E. Conway  
File No: SP13-021526

<b>TO:</b>	<b>CHAIR AND MEMBERS PLANNING AND ENVIROMENT COMMITTEE MEETING</b>
<b>FROM:</b>	<b>GEORGE KOTSIFAS, P.ENG MANAGING DIRECTOR, DEVELOPMENT AND COMPLIANCE SERVICES AND CHIEF BUILDING OFFICIAL</b>
<b>SUBJECT:</b>	<b>APPLICATION BY: HLH INVESTMENTS LTD. 1140 SOUTHDALE ROAD WEST PUBLIC SITE PLAN MEETING SEPTEMBER 10, 2013 after 4:15 PM</b>

### Enlarged Landscape Plan

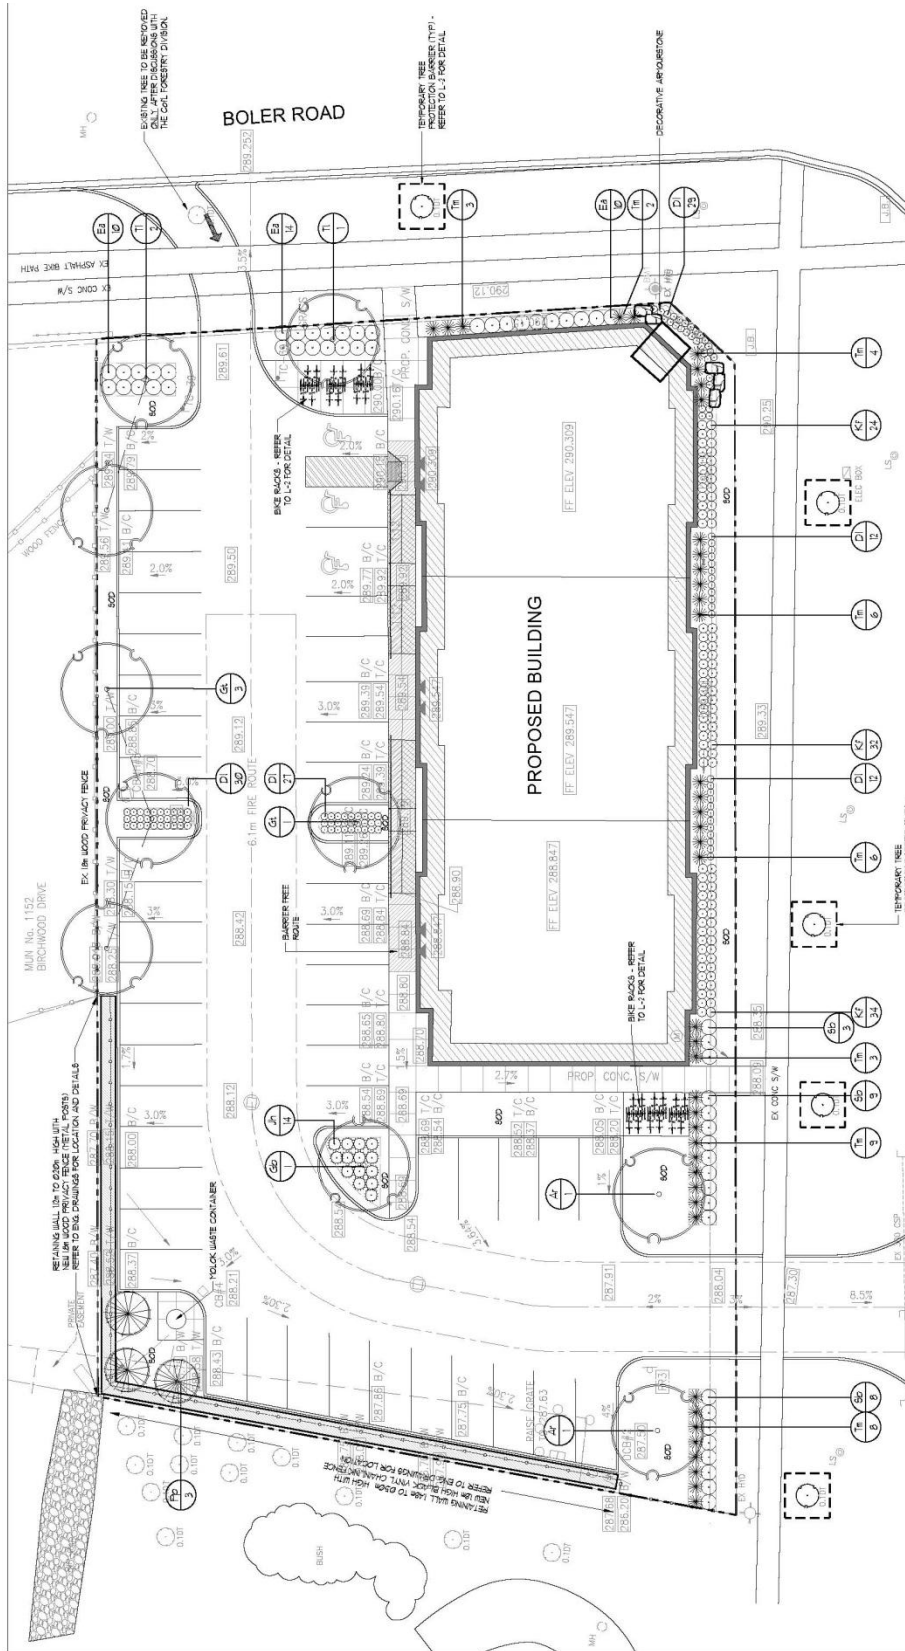
Provide landscaping on both sides of the vehicle entrance on Southdale Road West and on Boler Road to screen parking from the public realm.

Staff have raised concerns regarding the elevation changes between the parking area and residential properties to the north. Staff have requested that a minimum of 1.8 m visually permeable wood fence be proposed along the top of the retaining wall to limit the impact of vehicles headlights and control privacy into their back yard. Staff have also requested that the applicant meet with the three adjacent home owners to discuss alternatives for screening through landscaping or a taller fence be proposed as requested by the residents that is within reason. Staff have also required that the any existing privacy fences exceeding the minimum 1.8 m requirement will be retained or replaced if in poor condition as part of the discussion with the neighbours. Large canopy shade trees are proposed along the north property line where the retaining wall is not proposed to help aid in future screening for the properties to the north.

Privacy, noise and lighting are usual concerns when commercial uses are proposed adjacent to residential areas. The applicant has agreed to screen the roof top mechanical equipment and provide a minimum 1.8 m permeable wood fence along the top of the retaining wall along the north boundary. The only lighting proposed on the property is located on the building and is to be oriented downward and the applicant must enter into an agreement with the following clause "Lighting Facilities: All lighting of the site shall be oriented and its intensity controlled so as to prevent glare on adjacent roadways and residential properties to the satisfaction of the CBO." Details of the proposed external lighting will be reviewed by staff when they make a building permit applicant to ensure no lighting is oriented onto adjacent properties. The additional large
